SPRINGDALE SOLAR FARM

Independent Planning Commission

Request for Information (RFI) Report

Author	Steven Reid
Date	05 February 2021
Ref	04317-2039267

3.1 Biodiversity Corridor Plan

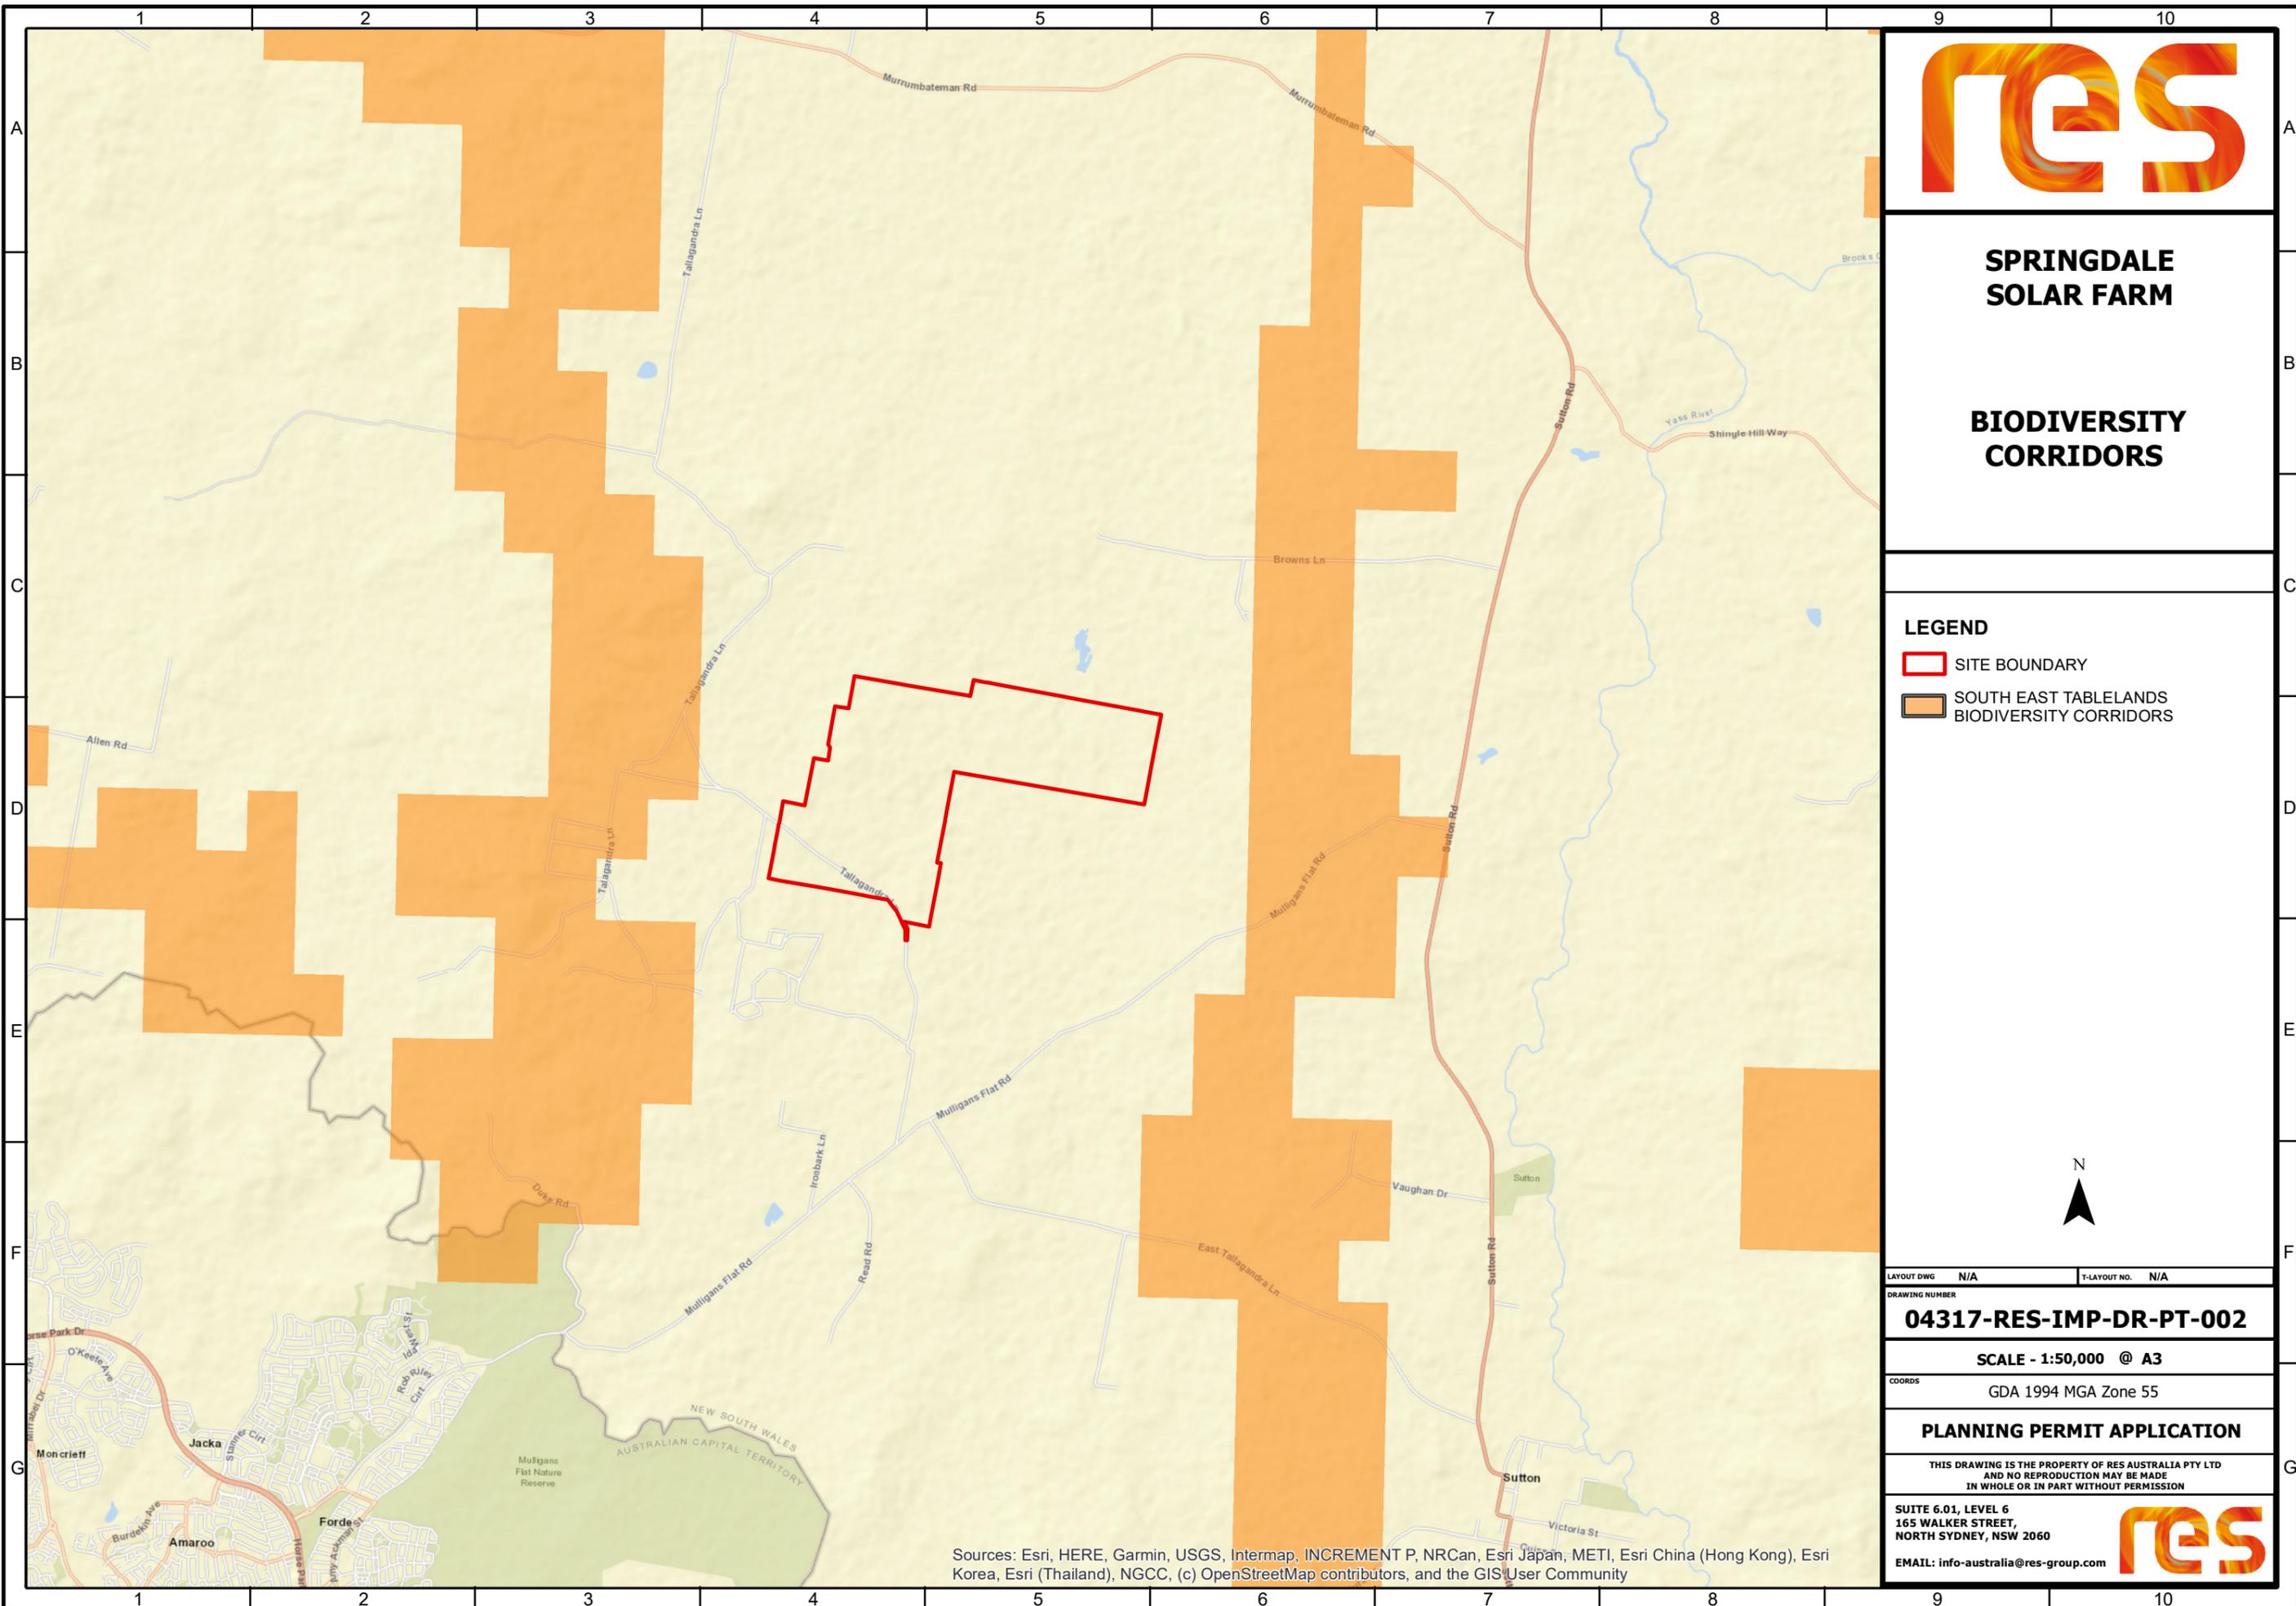
IPC - RFI	Proponent Response
<ul style="list-style-type: none"> - <u>Biodiversity corridor</u>: please provide maps. 	<p>See plan attached at Annexure 3.1</p>
<ul style="list-style-type: none"> - <u>Conservation area</u>: what works are proposed to enhance the area? How will grazing regimes be managed? 	<p>The conservation area referred to is assumed to be the Golden Sun Moth (GSM) conservation area located to the western side of the main solar array. This area comprises 60 ha set aside and managed for the benefit of GSM.</p> <p>As outlined in the EIS, the project was substantially redesigned to avoid key areas of GSM habitat within the Project site following expert ecological survey. This avoidance is the key element of the Proponent's response to conserving this species within the Site for the duration of the solar farm's operation.</p> <p>In addition to this, measures proposed with view to enhancing the habitat and success of this species within the Site include:</p> <ul style="list-style-type: none"> • Management of grazing regimes during operation to maintain optimal grass species, height and coverage. This will include specific management of the type of livestock (likely sheep) and the density of stocking to maintain key habitat values relevant to the species' long term success. Specifically, the Proponent will seek to maintain tussock levels between 3 and 15 cm by regulated grazing, with shorter heights achieved by October before the GSM flying period, and lighter grazing from November to January if the season is dry.
